Memorandum – Denial Memo

Applicant: Janette & William Crowe
Property Address: 2 Buttonwood Lane, Rumson, New Jersey 07760
Block 108, Lot 1, Zone: R-1

Construct new 461 square foot outdoor screened porch at the rear of the dwelling on a slightly irregular corner lot.

DRAWING:
COVER PAGE INFORMATION

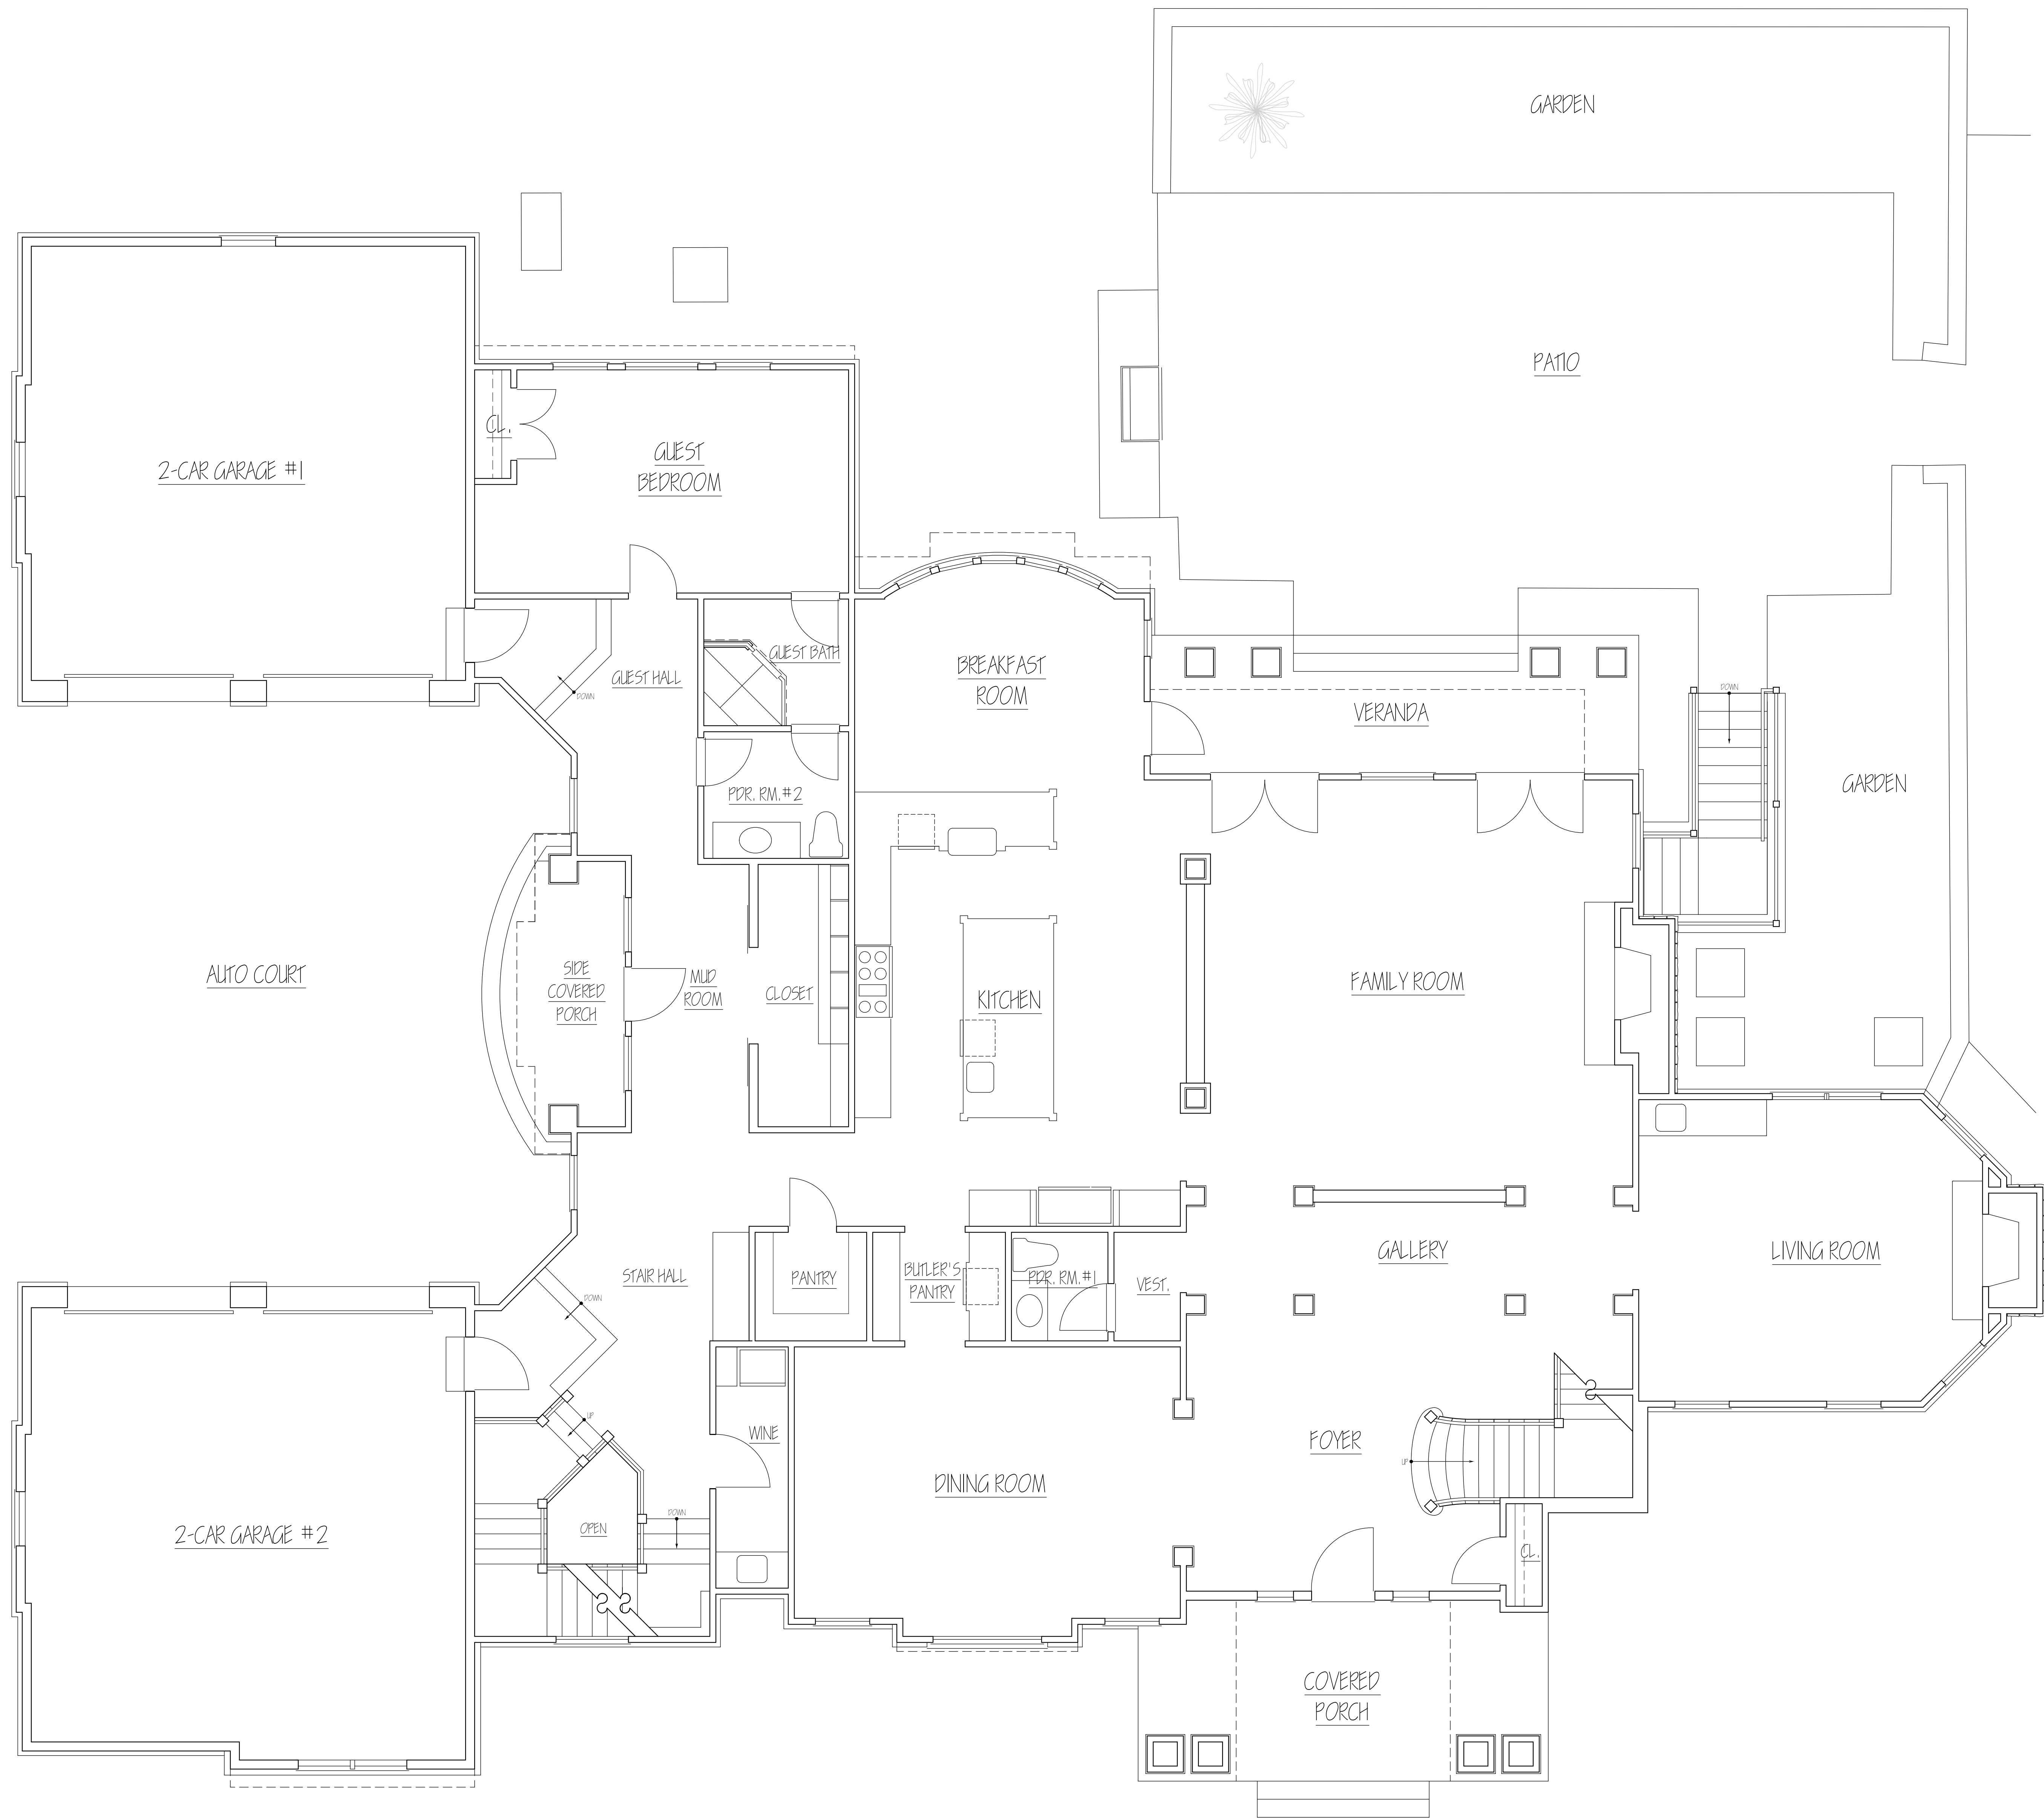
Prior to printing plans for the Zoning Board application please correct the existing Frontage in the Zoning Schedule to match the Survey and Resolution.
